UNITED STATES PATENT AND TRADEMARK OFFICE

APPLICATION NO.	FILING DATE	FIRST NAMED INVENTOR	ATTORNEY DOCKET NO.	CONFIRMATION NO.
09/928,725	08/13/2001	Randy E. Dewhirst	D-2550A/WOD	7156

**Office Action Summary**

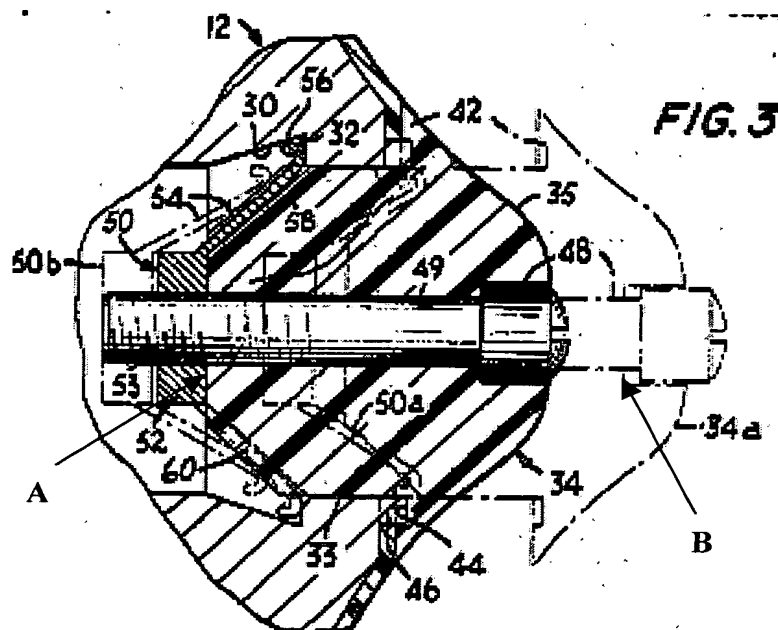
Claims 34-53 are rejected under 35 U.S.C. 102(b) as being anticipated by Zoehfeld (US 3,387,768). With regard to claim 34, Zoehfeld discloses a spacer body **34** comprising a front face **35** having an aerodynamic contour (column 2 lines 41-44) symmetrically arranged about an axis; a rear face axially spaced from the front face (see generally figures 1 and 3); a recessed [spring bearing] surface **58** in the rear face; a spring spacing abutment **A** projecting in an axial direction from the bearing surface **58** (see edited figure 3 below); and a central bore **49** (see figure 3; column 2 line 57).

With regard to claim 36, Zoehfeld shows the abutment A with at least one shoulder (intersection of abutment A and bearing recess 58).

With regard to claim 37, Zoehfeld shows the front face 35 of the spacer body 34 including a recess B (see edited figure 3 above).

With regard to claim 38, Zoehfeld shows an abutment A sized to control the axial load on an expensor 54 when the expensor 54 is located radially outward of the abutment A (see edited figure 3 above).

With regard to claim 41, Zoehfeld shows the abutment **A** including a second shoulder located proximal the axis (intersection of abutment **A** and center bore surface **49**) (see edited figure 3 above).

With regard to claim 42, Zoehfeld discloses a spacer for an impeller comprising a contoured spacer body **34** symmetrical about an axis and including a front surface **35** and a rear surface (see generally figures 1 and 3); the front surface **35** including a contoured surface at an angle or curve relative to the axis (see column 2 lines 41-44; figure 1 and 3); the rear surface including a spring spacing abutment **A** including a washer contact surface **A** at an end of the abutment **A** wherein the spring spacing abutment **A** is axially dimensioned relative to the axis so that a spacer assembly **52** contacting the abutment **A** defects at a desired amount (see edited figure 3 and column 3 lines 6-8).

With regard to claim 43, Zoehfeld further discloses the contoured spacer body **34** including a center portion having a recess **58** arranged in the rear surface about the spring spacing abutment **A** (see edited figure 3 above).

With regard to claim 45, Zoehfeld shows the front surface **35** including a recess **B** and a forward facing shoulder in the recess **B** (see edited figure 3 above).

With regard to claim 46, Zoehfeld further shows the recess **B** sized to ensure that the front [surface] **35** is seated flush across the central bore **49** in order to make a substantially continuous surface (see edited figure 3 above).

With regard to claim 49, Zoehfeld further shows the body **34** having an aerodynamic portion **35** extending slightly around the spring spacing abutment **A** (see edited figure 3).

With regard to claim 50, Zoehfeld also shows the rear surface providing an outer shoulder (intersection of abutment **A** and bearing recess **58**) spaced radially outwardly and an inner shoulder (intersection of abutment **A** and center bore surface **49**) surface spaced radially inwardly (see edited figure 3 above).

With regard to claim 52, Zoehfeld further shows the front face **35** including a recess **B** (see edited figure 3 above).
